BOARD OF COUNTY COMMISSIONERS
ORANGE COUNTY, FLORIDA

ADDENDUM NO. 4 / IFB NO. Y17-711-PH

SOUTH WATER RECLAMATION FACILITY FATS OILS AND GREASE (FOG)
AND SEPTAGE RECEIVING STATION

MECHANICAL
 FOG RECEIVING STATION PLAN

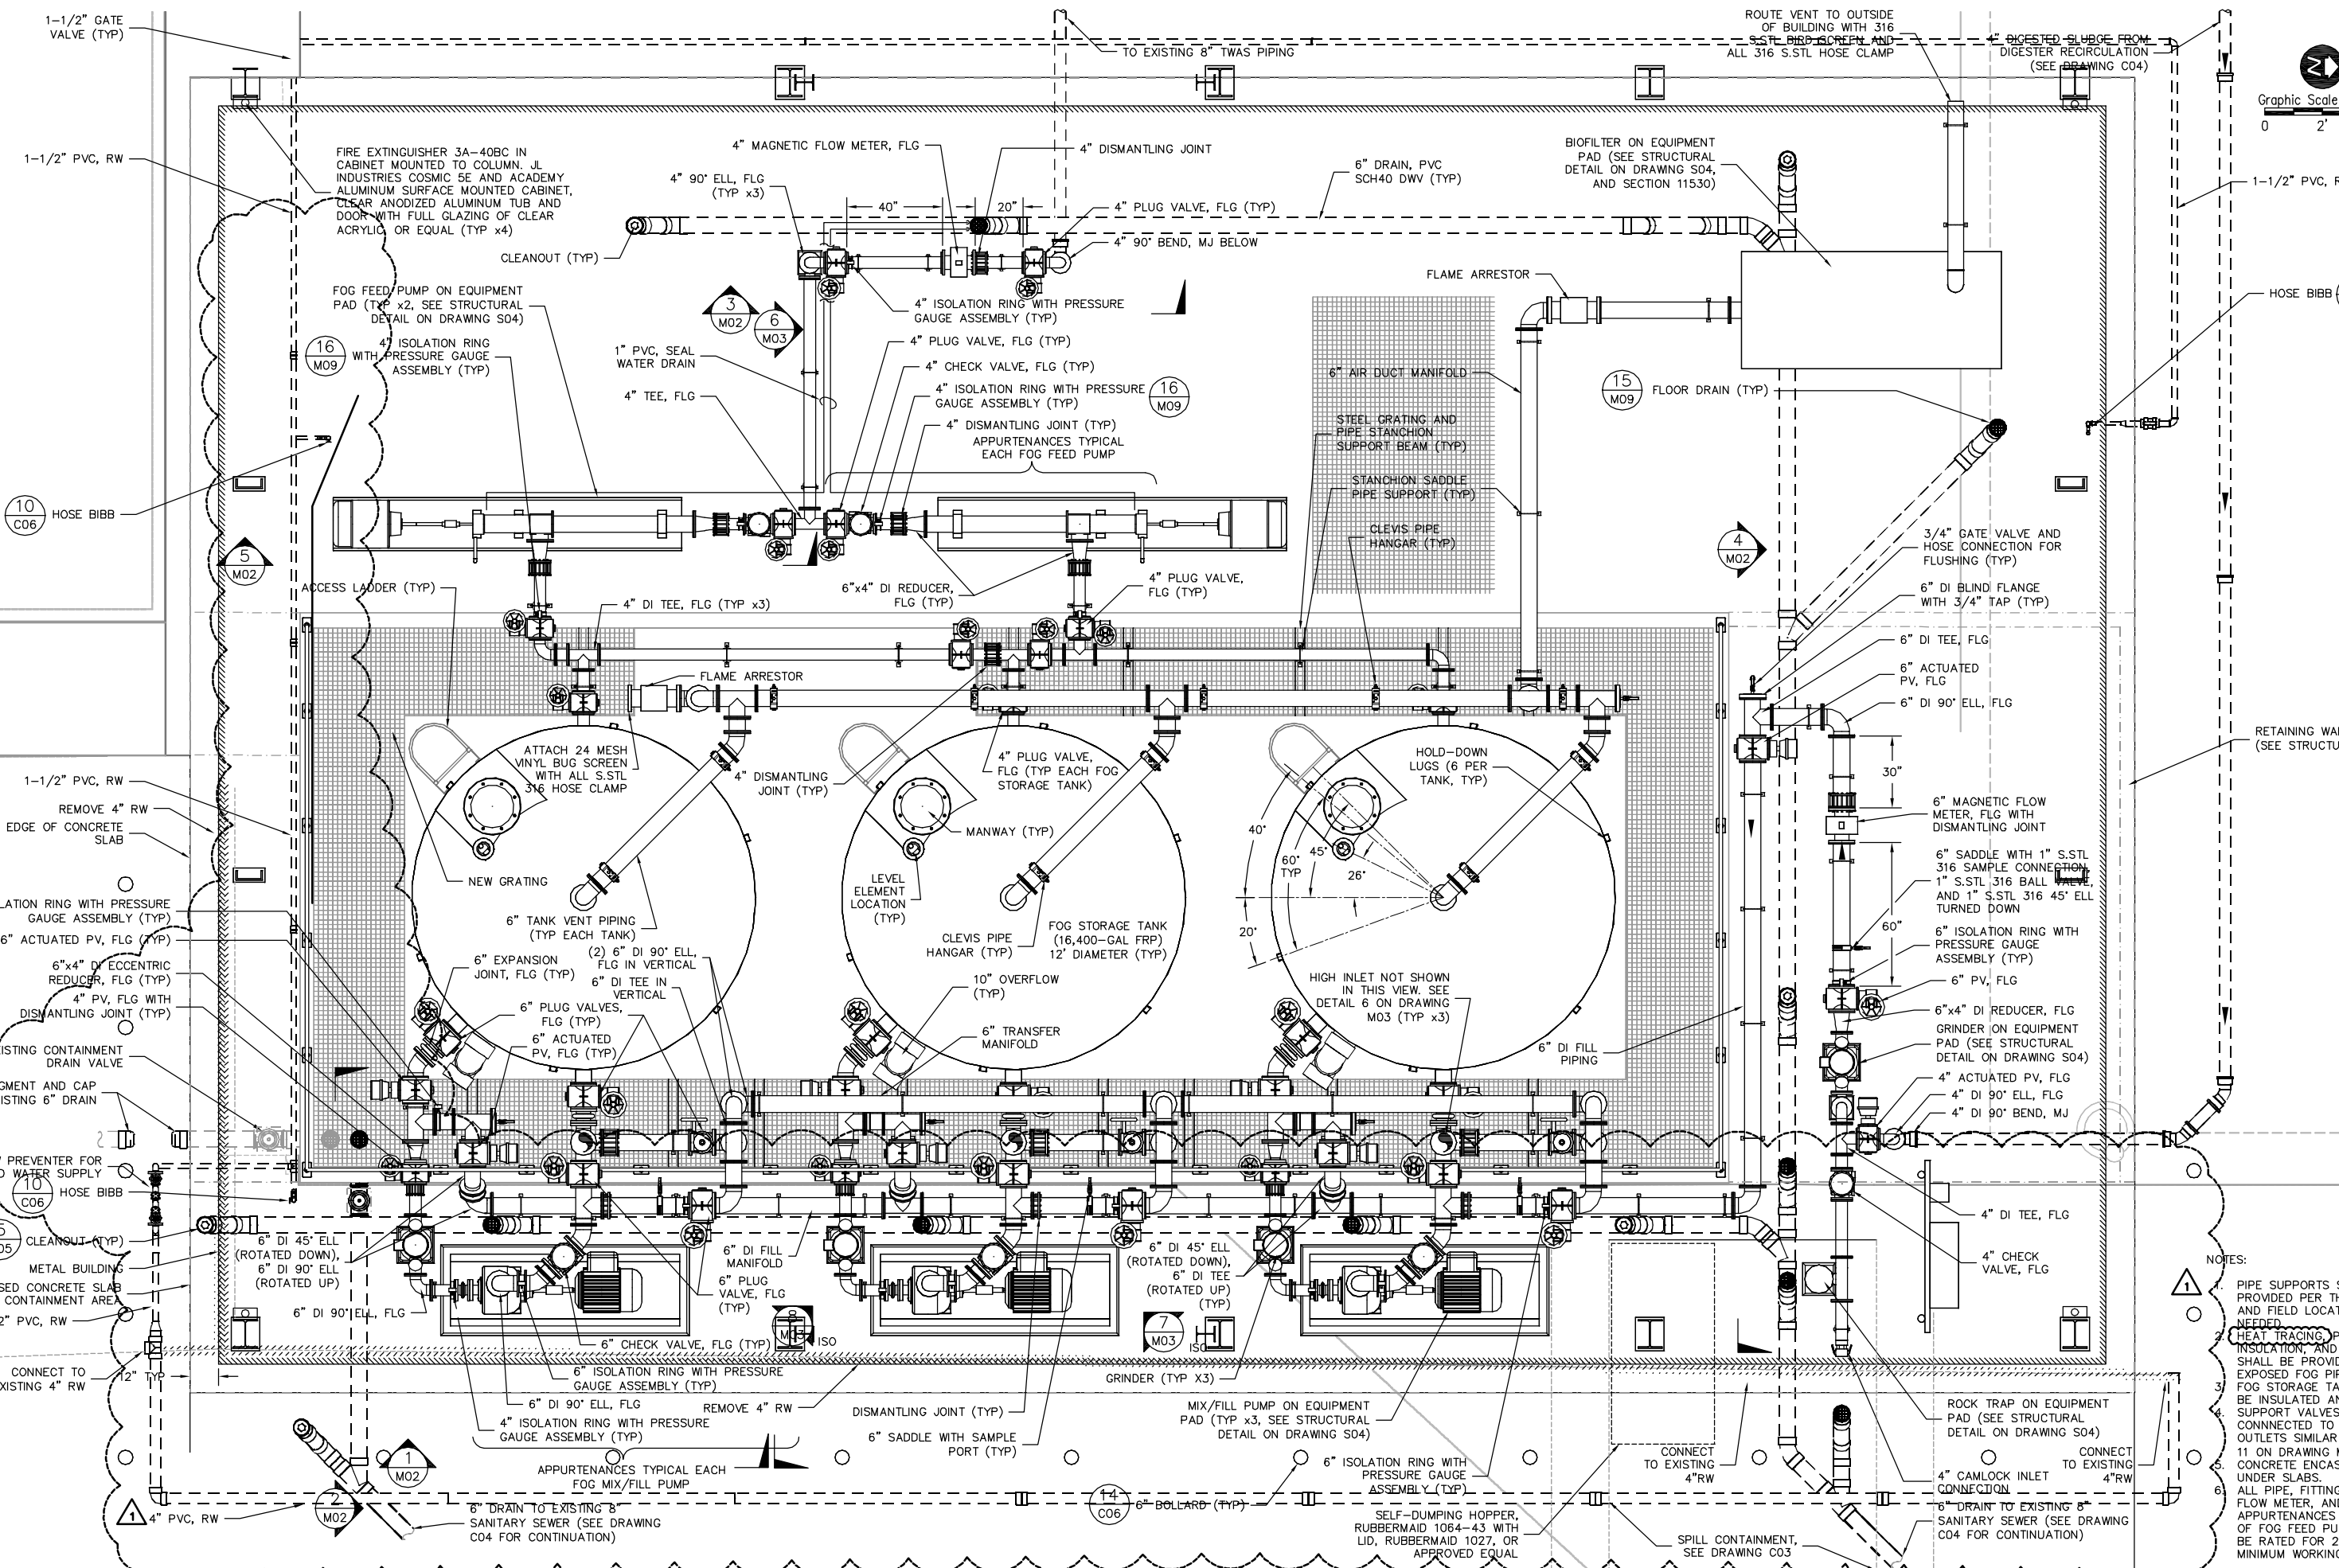
4. Q. Details on the reclaimed water line seem to vary between pages (M01 & C04), can you confirm the pipe sizes and valving requirements. Additionally, is encasement required for this line?

- 8. Q. Is encasement required on existing facilities located under the proposed concrete areas? If so, please detail the lines subject to this encasement.**

A. See revised drawings M01 attached.

- A. Existing facilities have been relocated from proposed concrete areas. See revised drawing M01 attached.
- 9. Q. Will septage deliveries be rerouted during construction operations or will the contractor need to coordinate continuing operations?**

ORANGE COUNTY UTILITIES
 SOUTH WATER RECLAMATION FACILITY FOG & SEPTAGE RECEIVING STATIONS
 CIVIL
 SITE PLAN AND PAVING & GRADING

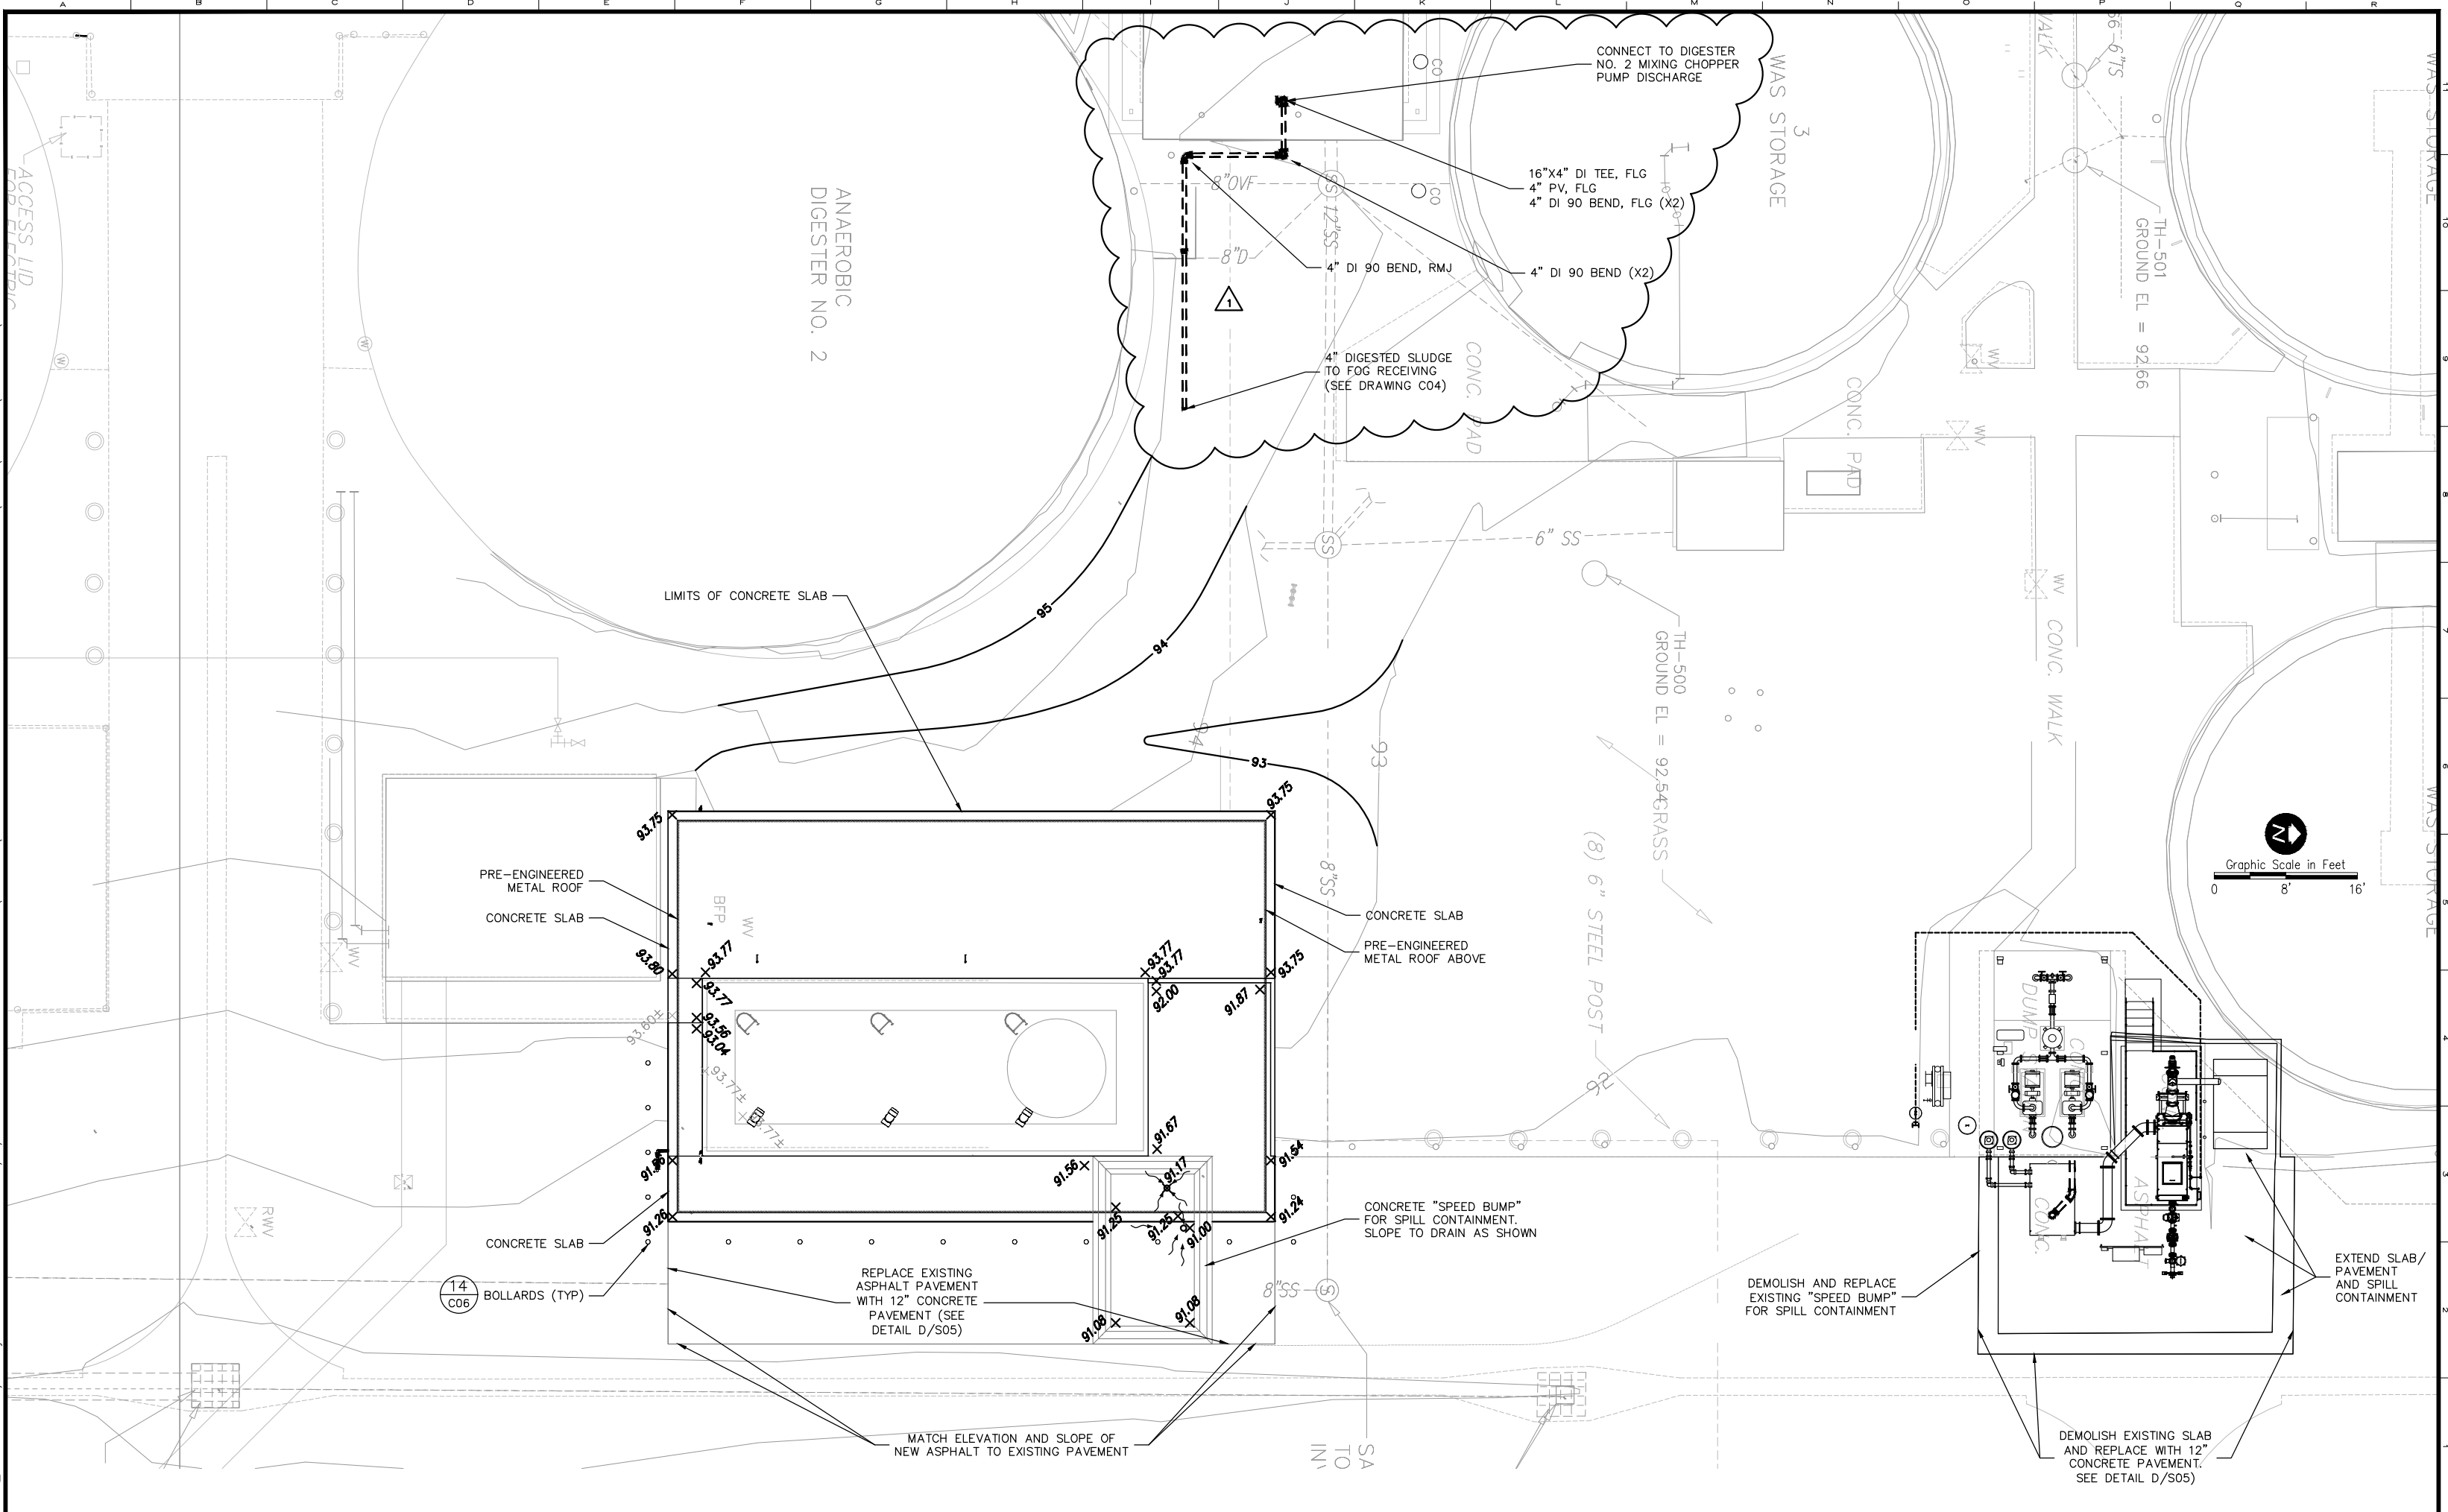
- A. No.
- 7. Q. Please confirm connection point of the 4" Digester Sludge Line. C04 does not indicate a termination point.**
- A. The intent is to connect the 4" digester sludge line to the Anaerobic Digester No. 2 recirculation system. Connection to be made by installing 16" x 4" flanged tee with 4" flanged plug valve on the 16" discharge line between Digester No. 2 Mixing Chopper Pumps. See revised drawing C03 attached.
